**Origination Form**  
Proposed Revisions to a Standard Plans Index

| <b>Originator:</b> | Meyer, Ronald and Lemus, Vivian | <b>Index Number:</b>    | 700-120                             |
| <b>E-mail:</b>     | Ronald.Meyer@dot.state.fl.us    | <b>Index Title:</b>     | ENHANCED HIGHWAY SIGNING ASSEMBLIES |

UPDATED Table of Contents

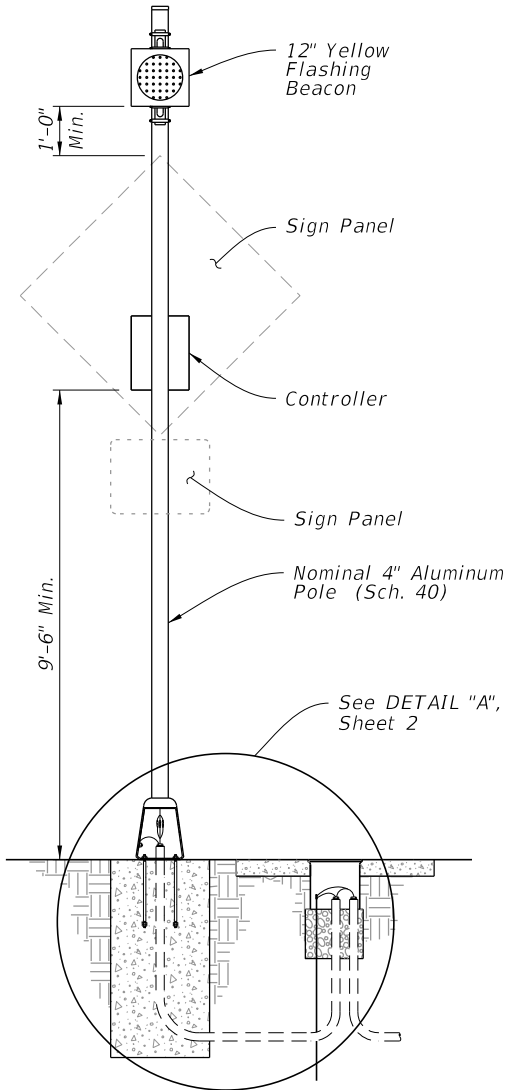
Sheet 1: Updated the Table of Contents.

DETAIL "A"

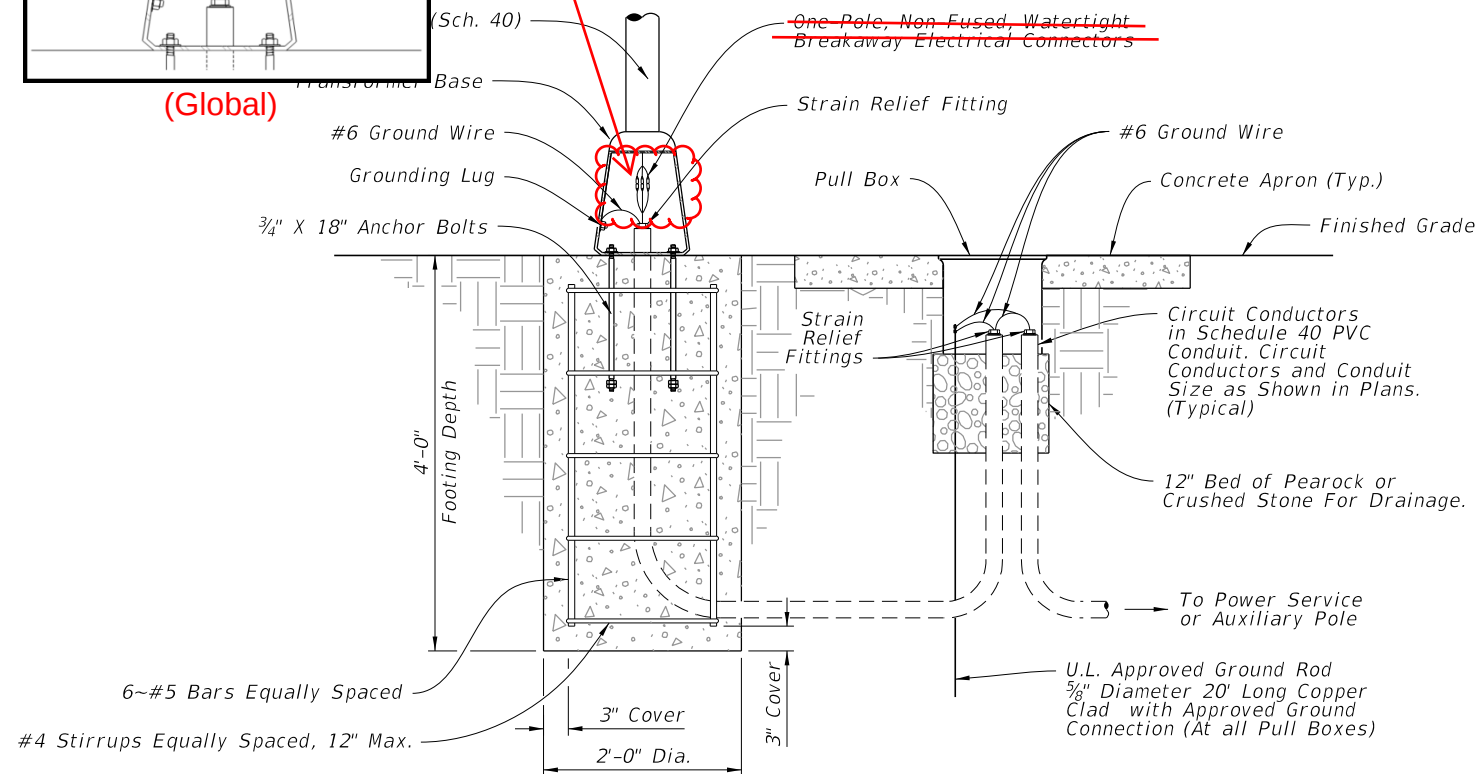
Sheet 2: Updated electrical component in Detail "A"

Sheet 2 - To improve the electrical safety and operational reliability of Enhanced Highway Signing Assemblies. The change reduces the likelihood of energized conductors being exposed after a knockdown event, minimizes equipment damage, and enhances overall system safety.

CHANGED TO:  
Single-Pole Fused and Single-Pole Non-Fused,  
Watertight Breakaway Electrical Connectors

ROADSIDE SIGN ASSEMBLY-2

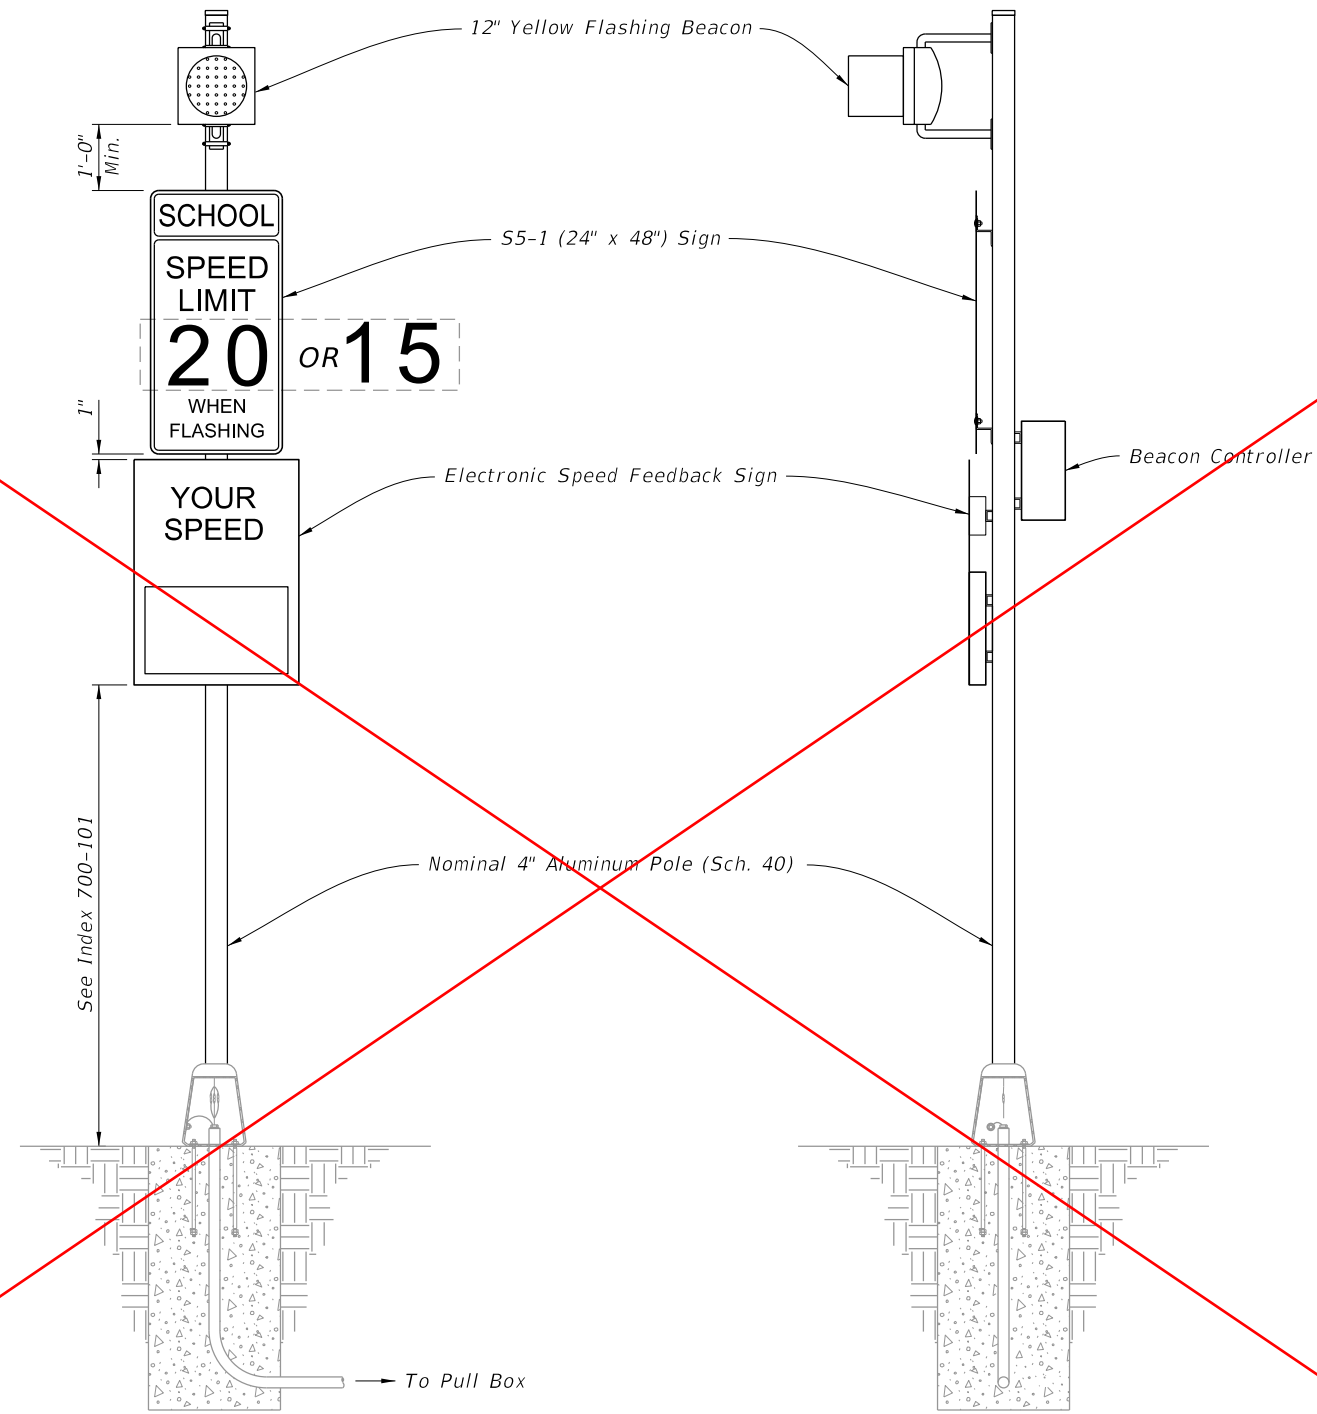
Sheet 5: Deleted dimensions for S5-1 and FTP-021-25; Changed the speed limits from "20 or 15" to "XX" to match figures in upcoming release of Speed Zoning Manual.

Sheet 5 - should be updated to remove specific dimensions for S5-1 and FTP-021-25 and clarify that speed limits can be other than 20 or 15 as appropriate (recommend changing to "XX" to match figures in upcoming release of Speed Zoning Manual); Added Callout "S4-3P Sign".
